BCA ASSESSMENT REPORT

**St Ignatius' College Riverview
Ignis Stage 2**

Revision: 3
Date: 26 August 2020
Reference: 200013

Figure 1

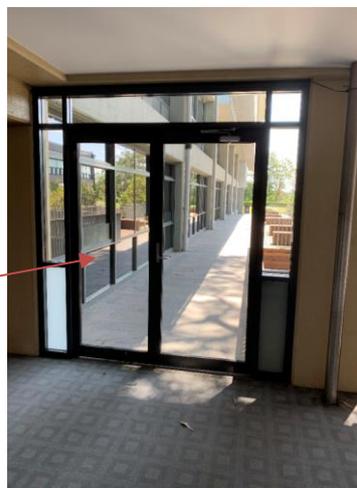
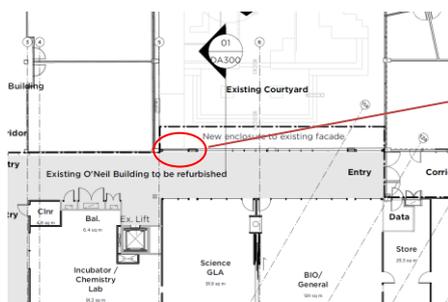
6. D1.2, D1.4 & D1.5	It is noted that the existing doorway to the External Circulation (shown in Figure 1) will be retained. This needs to be reflected on the plans (extract from updated plans shown below). Notwithstanding the above, we have re-assessed exit travel distances on the basis that this door will serve as an exit.

Figure 2

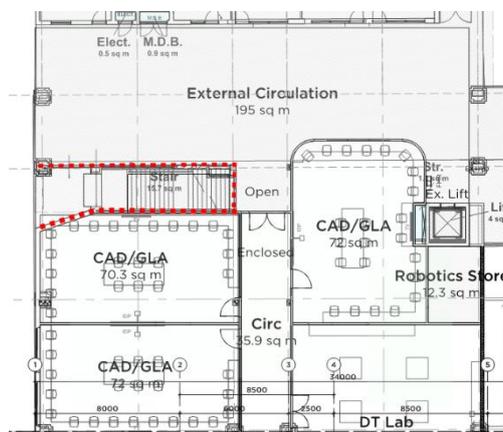
BCA (DtS) Clause	Description
<p>7. D1.3</p>	<p>The existing stair at Gridline 11 is not required to be fire isolated provided that it is fire separated from the remainder of the storey at Level 1 (as indicated in Figure 2). Fire separation must comprise construction having—</p> <ul style="list-style-type: none"> (A) an FRL of –/60/60, if non-loadbearing; and (B) an FRL of 90/90/90, if loadbearing; and (C) no opening that could permit the passage of fire or smoke <p>Where drencher protected glazing is proposed in this wall in lieu of fire resisting construction then a Performance Solution will be required (see below).</p>
<p>8. D1.6</p>	<p>The clear width at the base of the exit stairway (circled in Figure 3) connecting Levels 2 & 3 is currently 1.4m, whereas the width of the stairway is 1.8m. The clear width at the base of the stairway will need to achieve a minimum 1.5m, being the minimum required width of the exit stair.</p> <p>We understand that the width of this opening will be increased as part of the new works. Required dimension for this opening is to be added to the plans.</p>

Figure 8

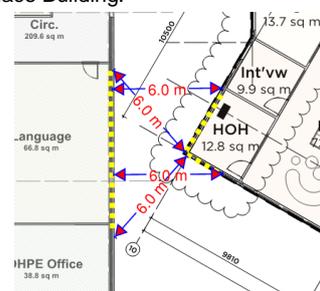
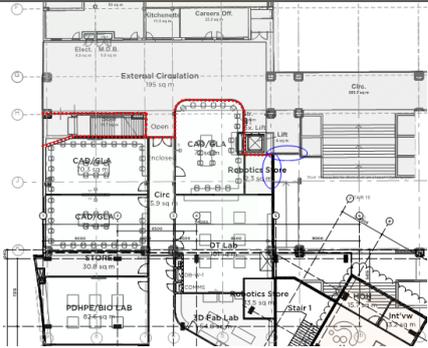
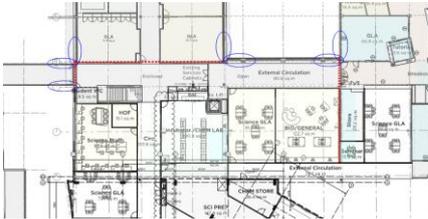
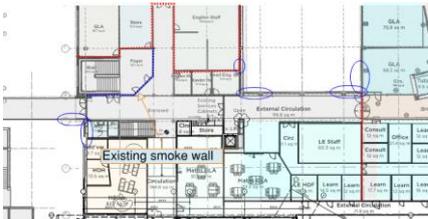
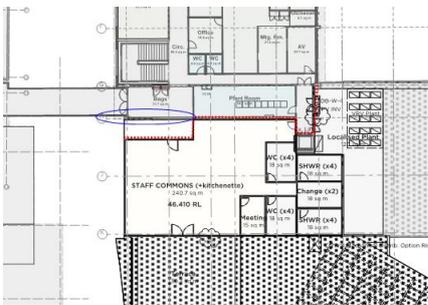
Angle between walls	Min. Distance	0° (walls opposite)	6m	More than 0° to 45°	5m	More than 45° to 90°	4m	<p>Performance Solution</p> <p>Protection of openings in external walls of different fire compartments will be required in the following locations (circled in blue).</p>
Angle between walls	Min. Distance									
0° (walls opposite)	6m									
More than 0° to 45°	5m									
More than 45° to 90°	4m

Note: The external wall construction surrounding any openings that require protection must achieve a minimum 1hr fire rating.

Figure 14

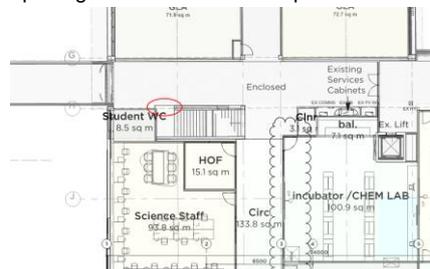
width of this opening will be increased as part of the new works. Required dimension for this opening is to be added to the plans

APPENDIX 5 – REQUIRED FIRE SEPARATION

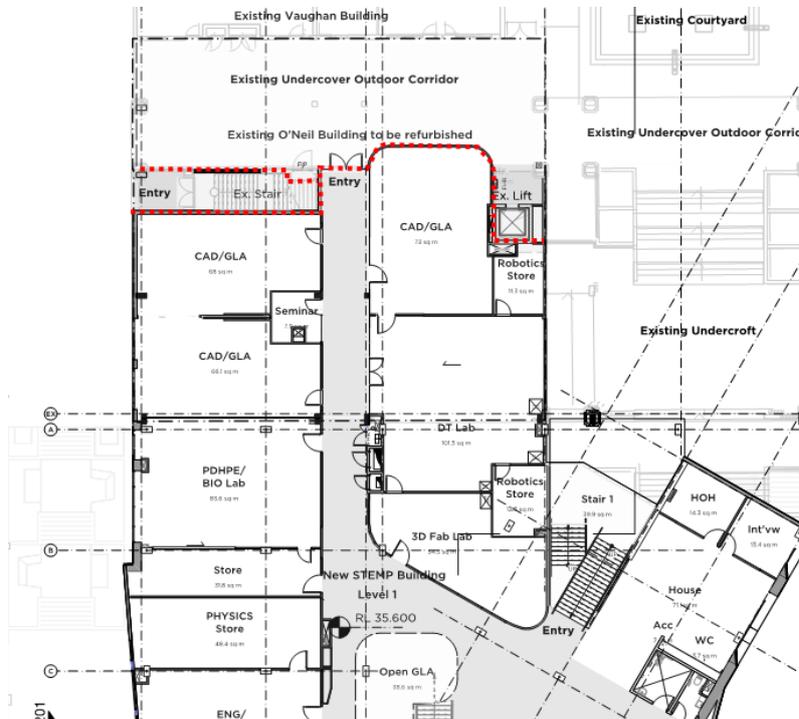
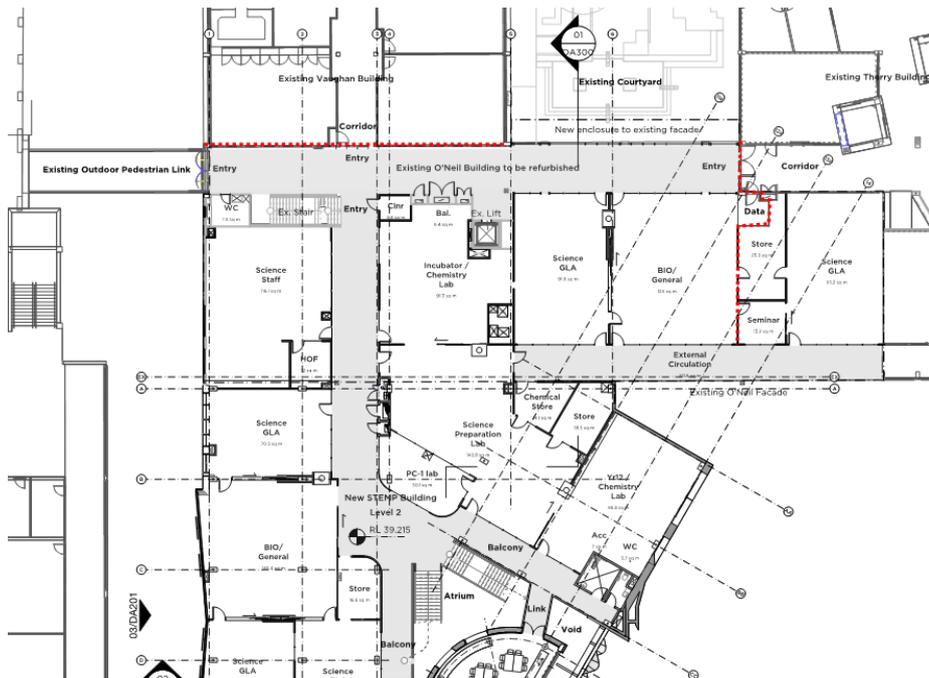
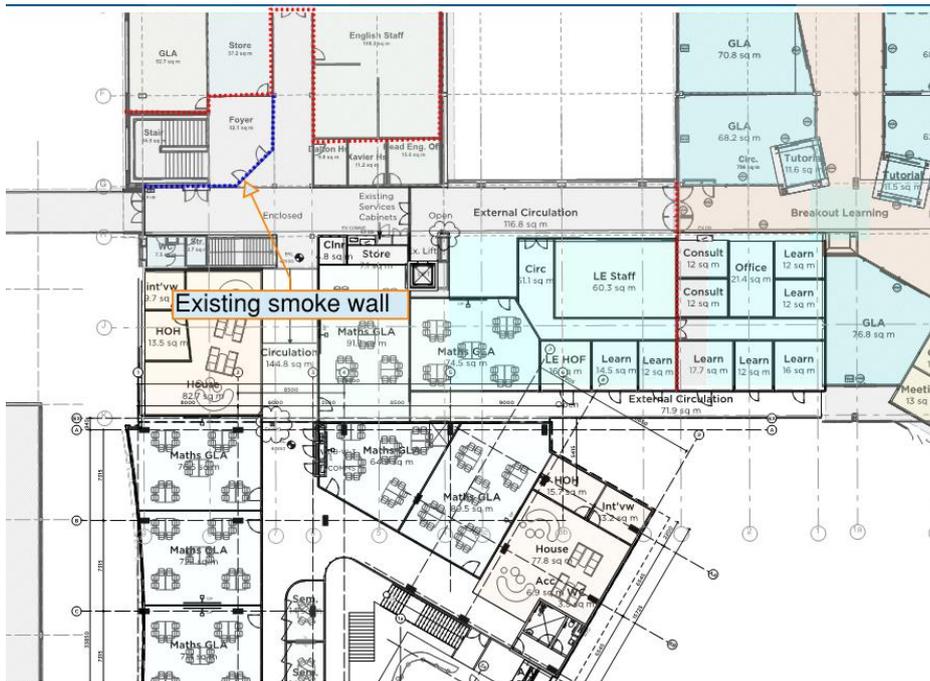
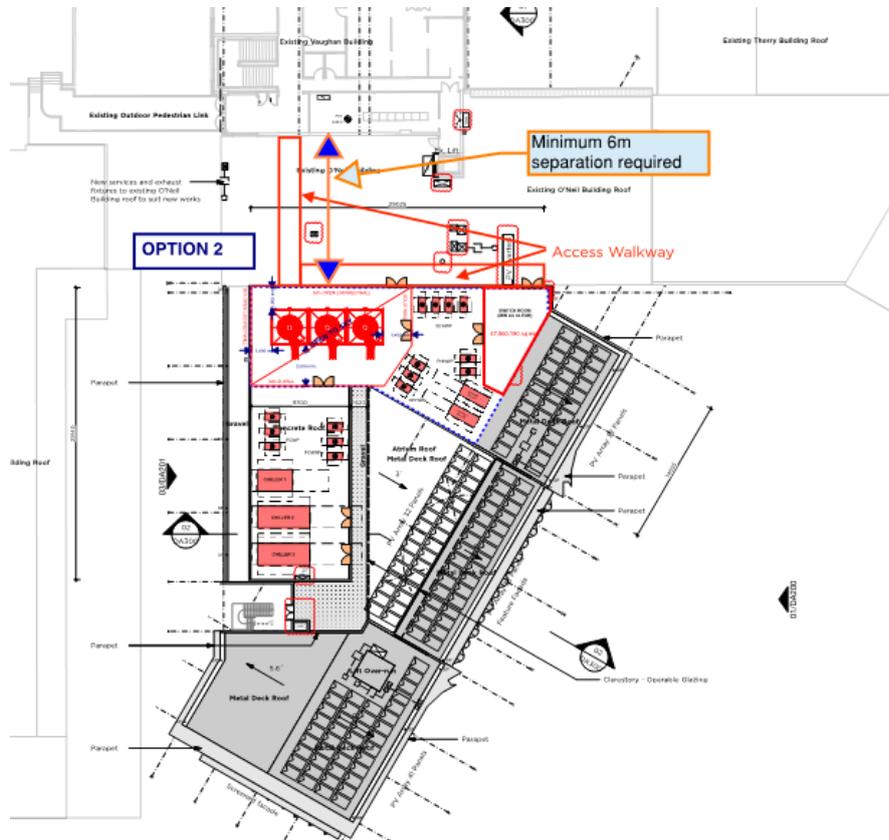
2. C1.1, Spec. C1.1, C2.7, C3.5	The new development will be fire separated from the existing building by 2hr fire walls in locations indicated in Appendix 5. While the existing and proposed parts will form one building, the fire walls will ensure that the existing level of fire safety will not be adversely impacted upon by the new addition, particularly with respect to fire compartmentation. Any existing walls that will form part of the required fire wall will need to be verified as achieving the required 2hr fire rating. In this regard, it is noted that the existing fire wall at Level 2 (Vaughan building) may only achieve a 1hr fire rating as indicated by the tags on the existing fire doors.

..... 120/120/120 FRL (2hrs) Required

Note: Fire separation between new and existing not required provided that minimum 6m separation is provided between the external walls. Switchroom to be fire separated in accordance with BCA clause C2.13.
